LRB Ref 188

Planning Application Reference 17/00590/APP Erection of a bungalow within garden ground at Rosemount, 5 Mayne Road, Elgin

Response from Transportation, Moray Council

Tmc 01 Annotated Extract from General Arrangement Drawing no. 17/ASH/PP01

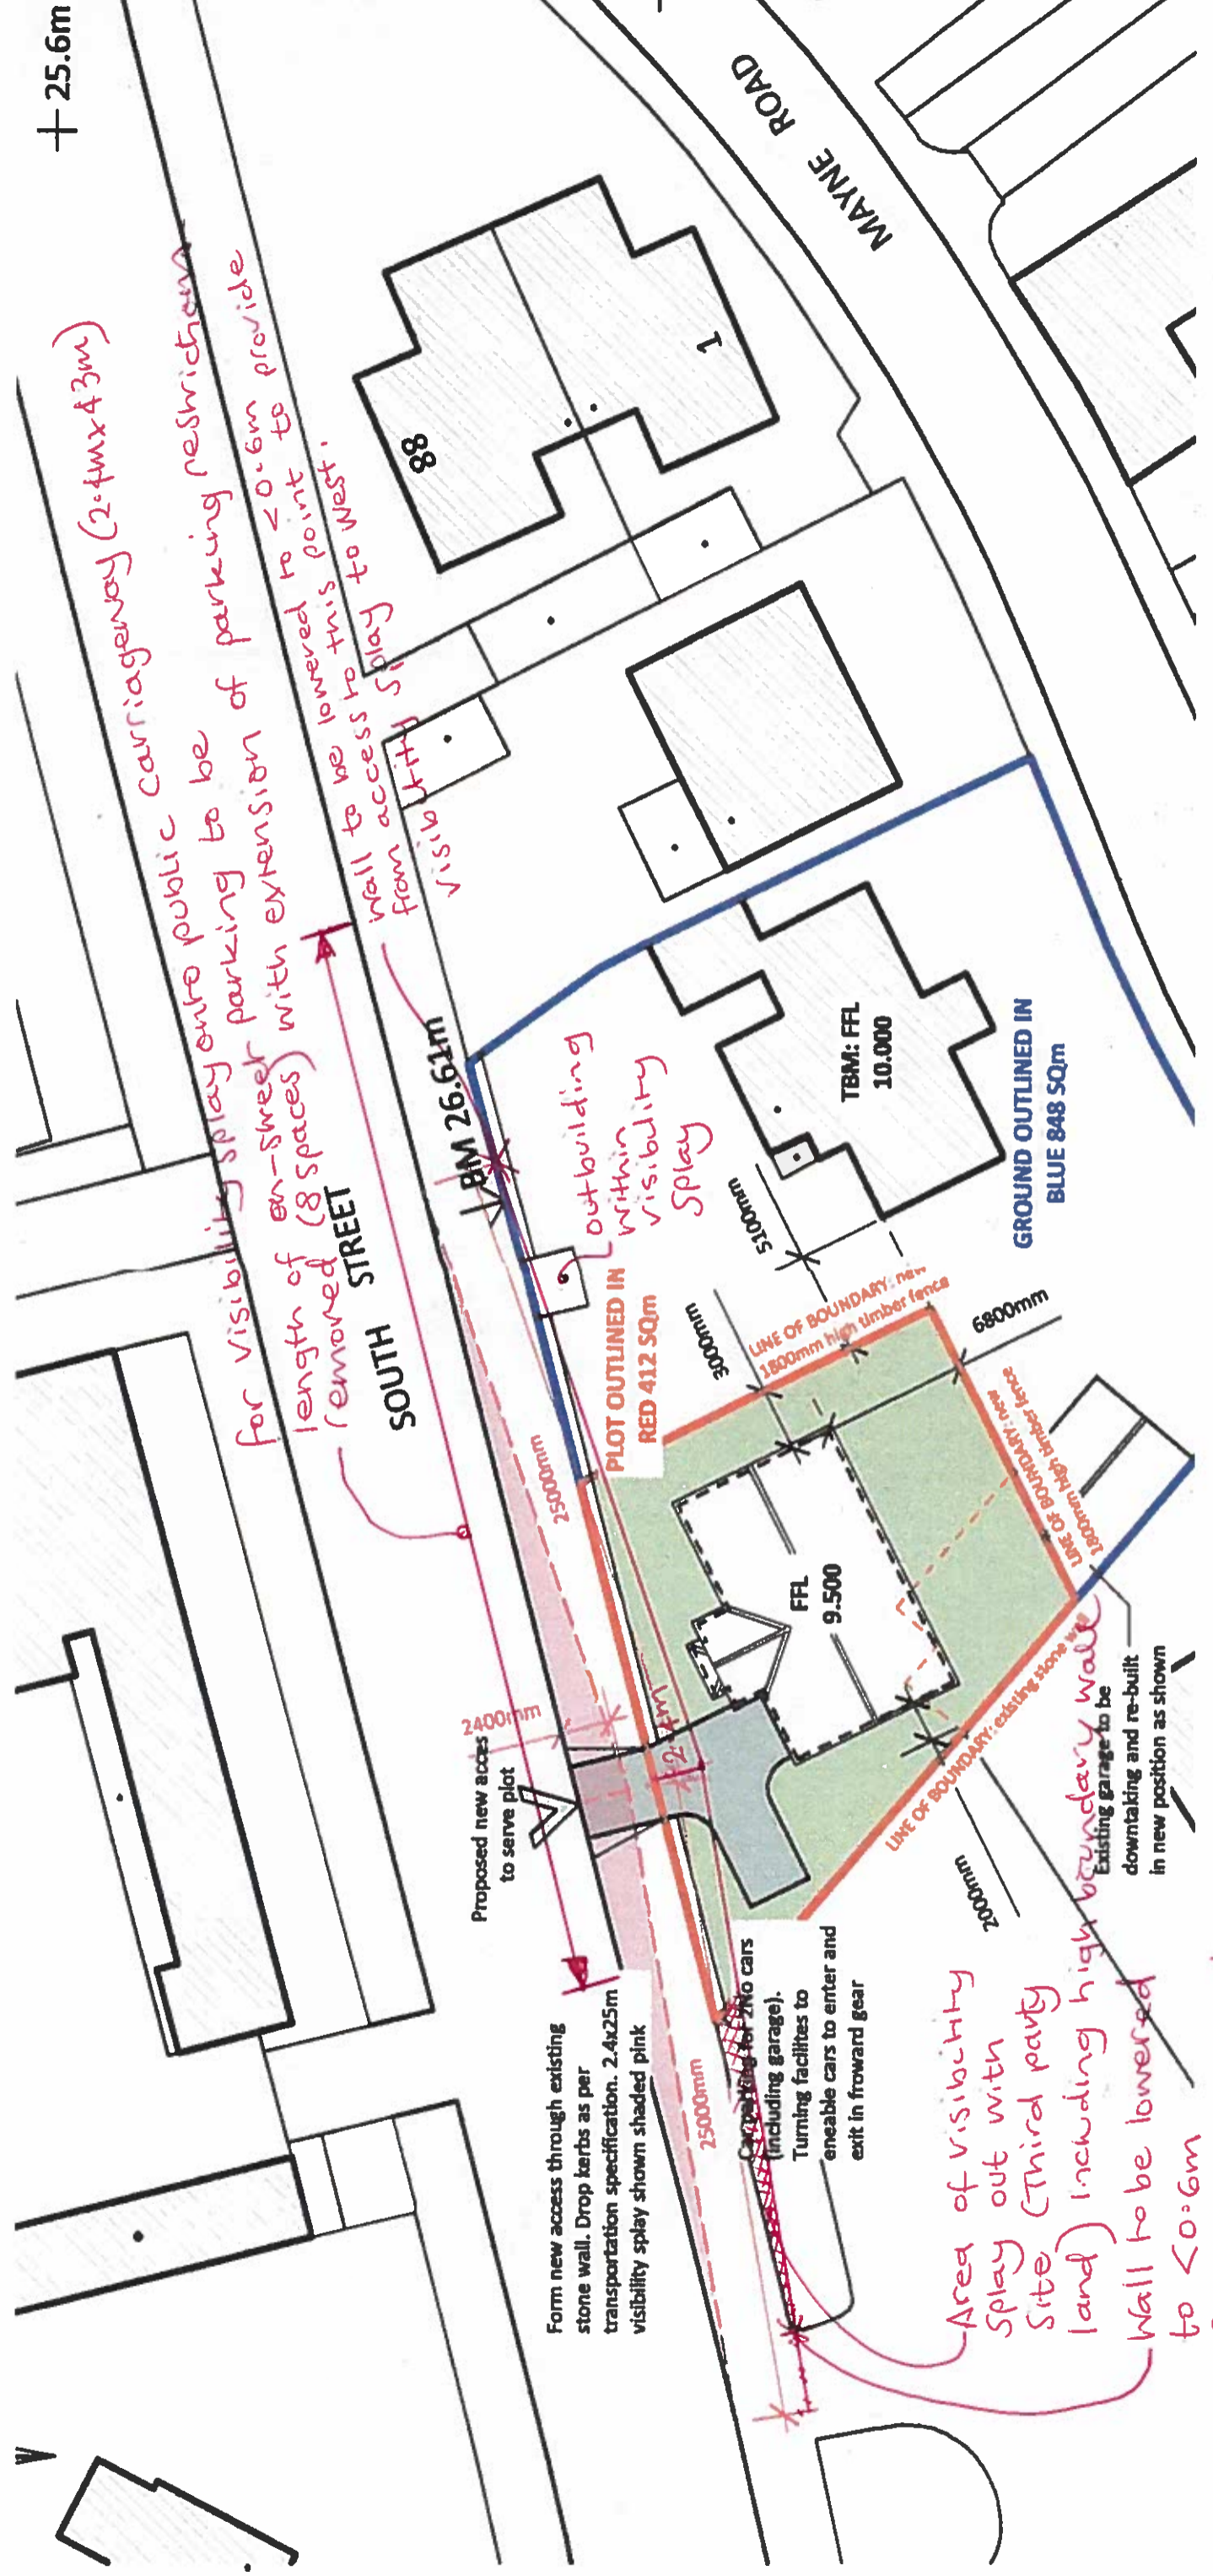
4. The minimum stopping sight distance for cyclists is 25 metres. Any new access onto South Street would therefore be required to provide a visibility splay of 2.4 metres by 25 metres onto the cycleway, in both directions. The extent of this visibility splay is illustrated on the attached annotated drawing extract from General Arrangement Drawing no. 17/ASH/PP01 (**TMC01**). Provision of this visibility splay would require the lowering of the stone boundary wall to a maximum height of 0.6 metres. This would include a section of stone wall to the west of the proposed access which lies out with the control of the appellant (as illustrated on the annotated drawing **TMC01**).

5. For the public carriageway the appellant's agent has shown a visibility splay of 2.4 metres by 25 metres in both directions. This would be appropriate for a road where vehicle speeds are 20 mph or less. For South Street, which has a wide carriageway width and has not been 'traffic calmed', the required visibility splay would be 2.4 metres by 43 metres, in both directions.

6. To provide this visibility splay the extent of formal parking which would need to be removed to form the proposed access would be longer than just the area directly in front of the access (a distance of some 46 metres which would equate to 8 parking spaces, as illustrated on the annotated drawing **TMC01**). 'Double yellow lines' to deter parking within the visibility splays be required, which would be the subject of a Road Traffic Regulation Order.

8. A total of 8 on-street parking spaces would be removed to enable the proposed access and provide the required visibility splays. A developer obligation would be sought to address the loss of parking. The most recent approved rate is £3950 per parking space (Approved at ED&I Committee on 3 May 2011).
9. As noted above in paragraph 6, a Road Traffic Regulation Order would be required to restrict parking in front of the access and within the visibility splays. The current cost of processing a Road Traffic Regulation Order is £1,208. This cost would need to be met by the appellant. The costs of all works associated with the implementation of the order (including the removal of existing road markings, new road markings etc.) would also need to be met by the appellant.

11. In this case the MLRB should note that the required visibility splay crosses land out with the control of the appellant within which there is currently a high stone wall obstructing the available sightlines for exiting vehicles.

for visibility splay onto public carriageway (2.4mx4.3m) length of on-sweep parking to be removed (8 spaces) with extension of parking restrictions for visibility splay to be lowered to this point to provide wall to access to this point to West. Visibility Splay from access to this point to West.

out-building within visibility splay

Area of visibility splay out with site (Third party land) including high boundary wall. Existing garage to be down-taken and re-built in new position as shown. Wall to be lowered to < 0.6m from access to this point to provide visibility splay to the east.

- i) a detailed drawing showing the access and visibility splay of 2.4 metres by 43 metres in both directions where vehicles enter the public carriageway, including the area to be the subject of a Road Traffic Regulation Order to restrict parking within the visibility splay, has been submitted to and approved in writing by the Council, as Planning Authority in consultation with the Roads Authority; and
- ii) thereafter no works shall commence on site until such time as a Road Traffic Regulation Order for the restriction of parking within the visibility splay has been secured by the Roads Authority.

- i) a detailed drawing (scale 1:500 which shall also include details to demonstrate control of the land) showing a visibility splay 2.4 metres by 25 metres in both directions at the access onto the public footway/cycleway, with all boundaries either lowered to a height of 0.6 metres or less (measured from the level of the public road), or set back to a position behind the required visibility splay, and a schedule of maintenance for the splay area shall be submitted to and approved by the Council, as Planning Authority in consultation with the Roads Authority; and
